KYOCERA Service Bulletin

SB Number:	SB 2GR-032	Creation Date: 01/10/2009
Subject:	Common use of parts at the paper cassette	
Model:	KM-3050/4050/5050, KM-C2520/3225/3232/2525E/3232E/4035E, PF-700/710

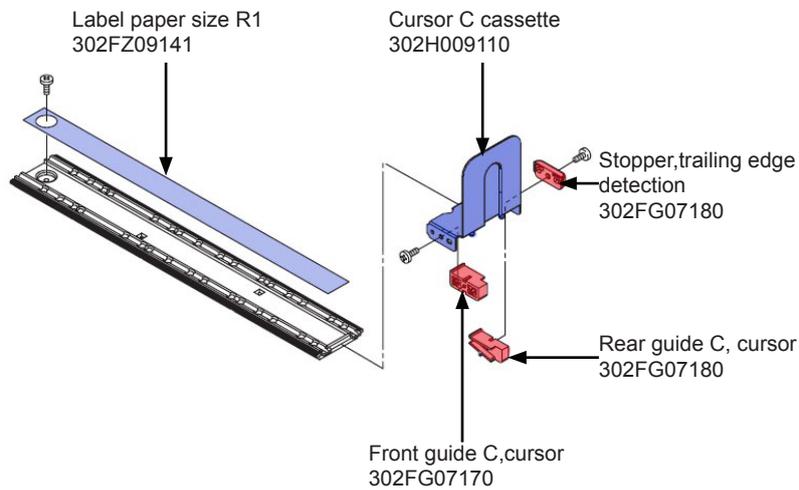
Phenomenon	<p>To make the parts at the paper cassette common with other models, the following changes have been made:</p> <ol style="list-style-type: none"> 1. The material of the cursor C cassette 302H009110 has been changed from metal to plastic. 2. The paper guide lines at the label paper size R1 302FZ09141 have been shifted 3mm to the right, due to the increased thickness of the new cursor C cassette. 3. Based on the above mentioned changes, the following parts have been discontinued: <ul style="list-style-type: none"> • Front guide C,cursor 302FG07170 • Rear guide C,cursor 302FG07180 • Stopper,trailing edge detection 302FG07230
-------------------	--

- Item 1:** The material of the cursor C cassette has been changed from metal to plastic
- Item 3:** Discontinued parts

- Item 2:** The guide line at the label paper size R1 has been shifted 3mm to the right.

Classification	<input type="checkbox"/> Entire stock rework	<input type="checkbox"/> In-field modification at next visit	<input checked="" type="checkbox"/> In-field modification by case	<input type="checkbox"/> No modification necessary
Field measure	Please do not mix old with new parts, when replacing the parts.
